Project	IEEE 802.16 Broadband Wireless Access Working Group < http://ieee802.org/16 >
Title	Correction of U-TDOA Measurement Procedure
Date Submitted	2006-11-06
Source(s)	Jaesun Cha, Kwangjae Lim, and, Chulsik Yoon jscha@etri.re.kr ETRI 161 Gajeong-dong, Yuseong-gu Daejeon 305-700 Korea
Re:	Contribution on comments to IEEE 802.16g/D5
Abstract	Correction of U-TDOA Measurement Procedure
Purpose	Adoption
Notice	This document has been prepared to assist IEEE 802.16. It is offered as a basis for discussion and is not binding on the contributing individual(s) or organization(s). The material in this document is subject to change in form and content after further study. The contributor(s) reserve(s) the right to add, amend or withdraw material contained herein.
Release	The contributor grants a free, irrevocable license to the IEEE to incorporate text contained in this contribution, and any modifications thereof, in the creation of an IEEE Standards publication; to copyright in the IEEE's name any IEEE Standards publication even though it may include portions of this contribution; and at the IEEE's sole discretion to permit others to reproduce in whole or in part the resulting IEEE Standar

Figure G3 – UTDOA Measurement Algorithm

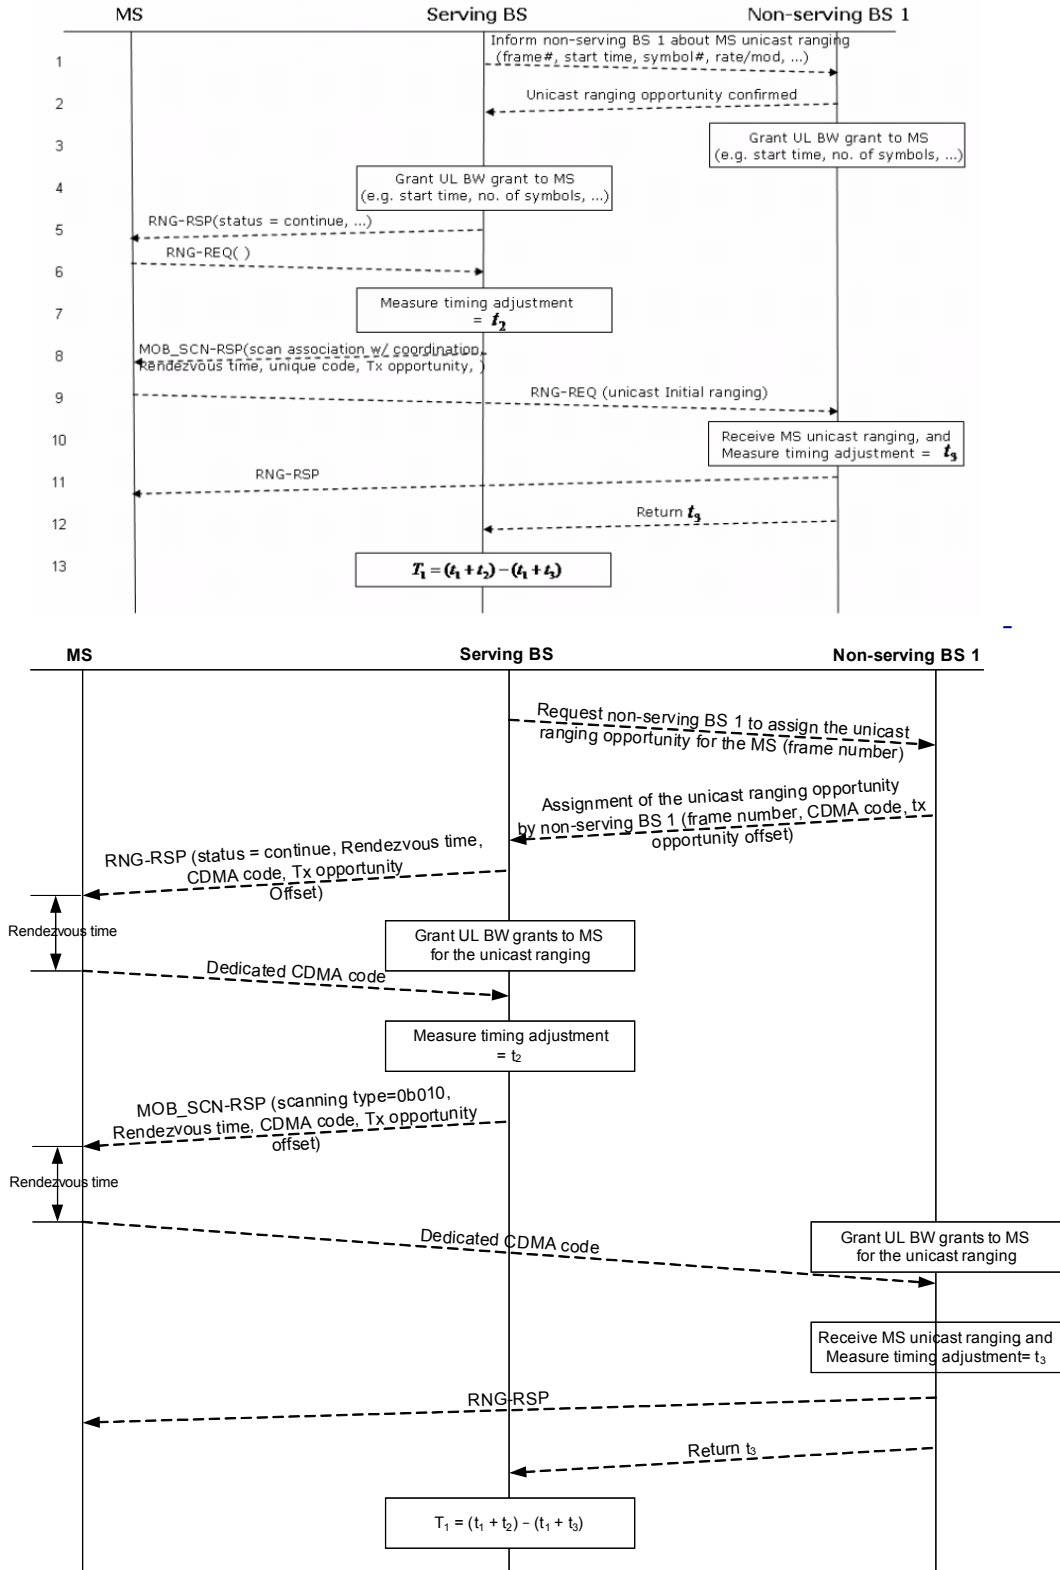
5. ~~Serving BS sends an autonomous RNG-RSP message to ask MS performing unicast ranging~~
 6. ~~When MS receives the RNG-RSP from serving BS, it shall send RNG-REQ at the assigned slot~~

7. ~~Serving BS 1 measures Timing Adjustment t_2~~
 8. ~~Serving BS sends autonomous MON_SCN-RSP with scanning type = 0b10 (scan association with coordination) to force MS performing initial ranging after scan~~

9. ~~MS synchronized with non-serving BS 1, and sends RNG-REQ~~
 10. ~~Non-serving BS 1 receives unicast ranging, and measures Timing Adjustment t_2~~
 11. ~~Non-serving BS returns RNG-RSP to MS~~

12. ~~Non-serving BS returns t_2 to serving BS~~
 13. ~~Serving BS reads the Timing Advance t_1 that was captured previously, and calculate U-TDOA~~
1. Serving BS requests non-serving BS 1 to assign the unicast ranging opportunity for the MS.

2. Non-serving BS 1 confirms the allocation of the unicast ranging opportunity for the MS and returns the related parameters, which includes frame number, CDMA code and transmission opportunity offset.

3. Serving BS sends an autonomous RNG-RSP message to ask MS performing unicast ranging. The unicast ranging information is included in RNG-RSP message.

4. Serving BS allocates a UL slot for MS to do unicast ranging which means “dedicated ranging indicator” bit of the UL-MAP IE shall be set to 1.
 5. When MS receives the RNG-RSP from serving BS, it shall send the allocated CDMA code at the assigned slot.

6. Serving BS 1 measures Timing Adjustment t_2
 7. Serving BS sends autonomous MOB_SCN-RSP with scanning type = 0b10 (scan association with coordination) to force MS performing initial ranging after scan. Rendezvous time, CDMA code and transmission opportunity offset shall be included in the MOB_SCN-RSP message.

8. Non-serving BS 1 grants UL slot to the MS and sets “dedicated ranging indicator” bit of the UL-MAP IE to 1 to use the allocated region for the purpose of unicast ranging.

9. After the rendezvous time from the reception of the MOB_SCN-RSP, MS synchronized with non-serving BS 1, and sends the allocated CDMA code at the allocated transmission opportunity offset.

10. Non-serving BS 1 receives unicast ranging, and measures Timing Adjustment t_3
 11. Non-serving BS returns RNG-RSP to MS
 12. Non-serving BS returns t_3 to serving BS

13. Serving BS reads the Timing Advance t_1 that was captured previously, and calculate U-TDOA

Figure G5 – U-TDOA Measurement Algorithm

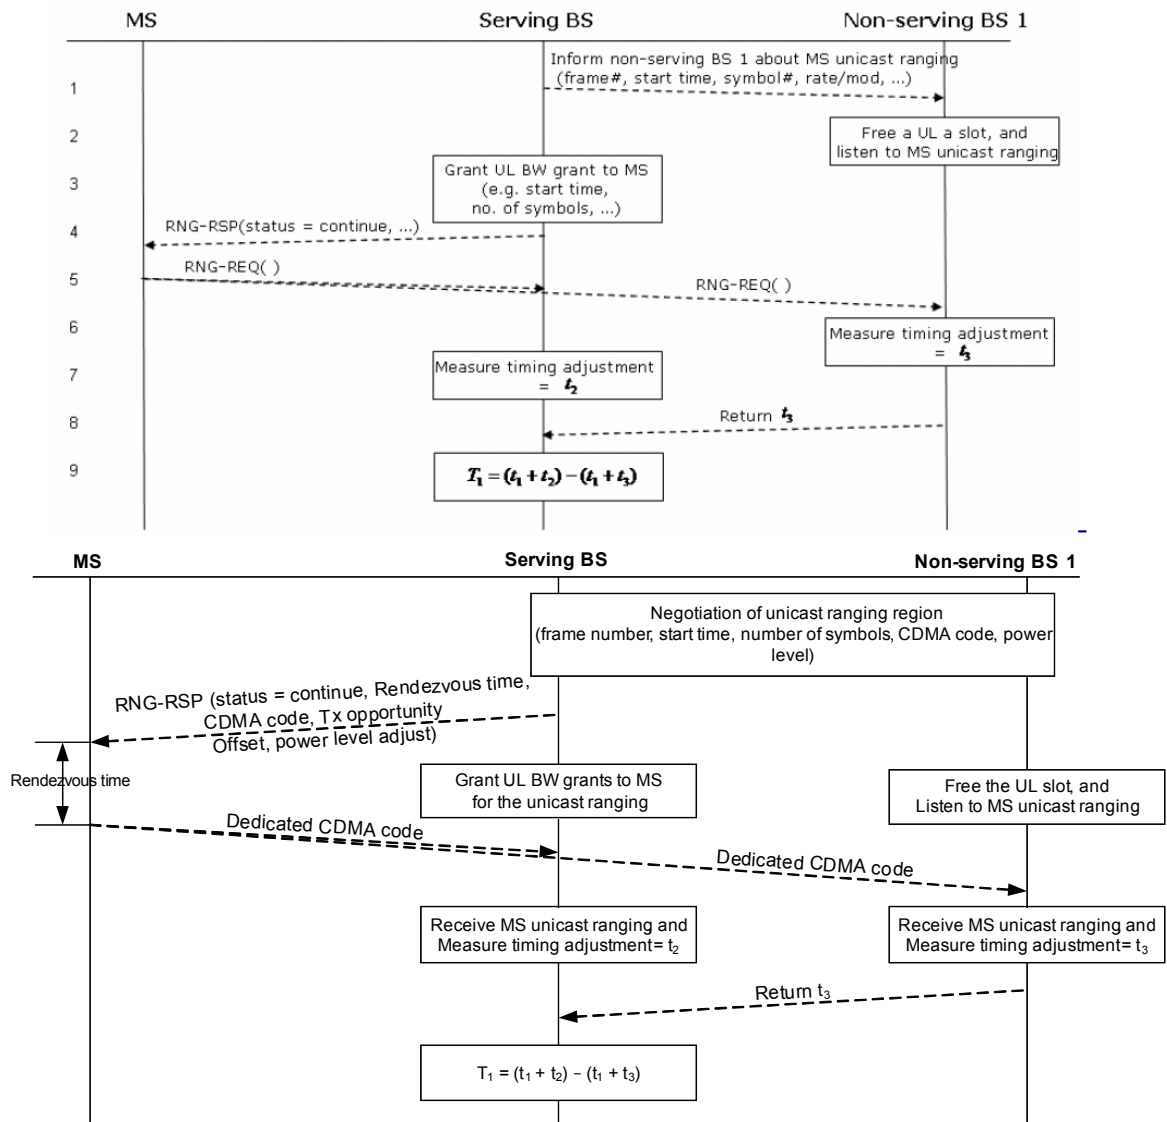
1. Serving BS informs non-serving BS 1 about MS is going to do unicast ranging by passing frame number, start time, number of symbols,
 2. Non-serving BS 1 does not grant such UL slot to the MS, and listens to the unicast ranging from MS

3. Serving BS allocates a UL slot for MS to do unicast ranging.
 4. Serving BS sends an unsolicited RNG-RSP message to ask MS performing unicast ranging

5. When MS receives the RNG-RSP from serving BS, it shall send RNG-REQ at the assigned slot that can be received by non-serving BS.
 6. Non-serving BS 1 measures Timing Adjustment t_3 .

7. Serving BS measures Timing Adjustment t_2
 8. Non-serving BS 1 returns t_3 to serving BS
 9. Serving BS reads the Timing Advance that was captured previously, and calculates U-TDOA
-

1. Serving BS and non-serving BS 1 negotiate the allocation of the unicast ranging region for the MS.
 2. The serving BS sends an unsolicited RNG-RSP message to ask MS performing the unicast ranging. The unicast ranging information is included in the RNG-RSP message.

3. The serving BS allocates a UL slot for MS to do unicast ranging at the pre-assigned rendezvous time. The non-serving BS 1 does not grant such UL slot to any MSs at the pre-assigned rendezvous time and listens to the unicast ranging from the MS.
4. When the MS receives the unsolicited RNG-RSP from the serving BS, it shall send the dedicated CDMA code at the assigned slot. The transmission power shall be changed based on the power level adjust parameter included in the receive RNG-RSP message to allow the non-serving BS to receive the code successfully.
5. The non-serving BS 1 measures Timing Adjustment t_3
6. The serving BS measures Timing Adjustment t_2
7. The non-serving BS 1 returns t_3 to serving BS
8. The serving BS reads the Timing Advance that was captured previously, and calculates U-TDOA
